No. EL/2.2.9/3

SPECIAL MAINTENANCE INSTRUCTION NO. ELRS/SMI/0232 - 2004 (REV 0)

Improvement in the reliability of Pulse Generator of Speedometer.

PROCEDURE OF HOLDING PG CORRECTLY

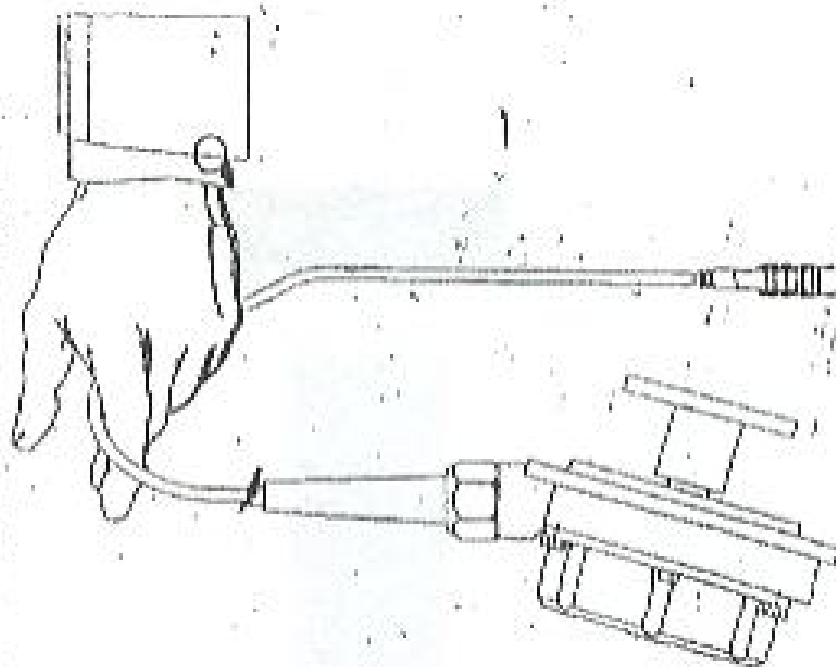
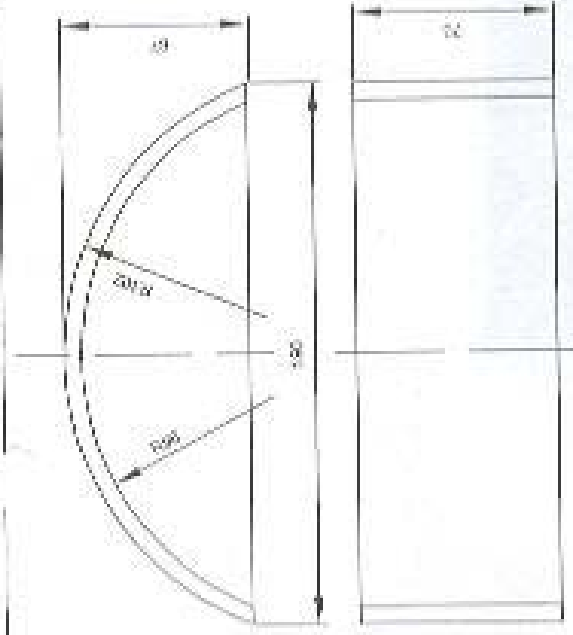
- xiv. Driving Pin should be 32 mm from center of Axle Box End Cap.
- xv. Do not hold PG from cable while carrying from one place to another, it can cause internal breakage in cable conductor, instead hold PG assembly by hand as shown in Annexure enclosed.
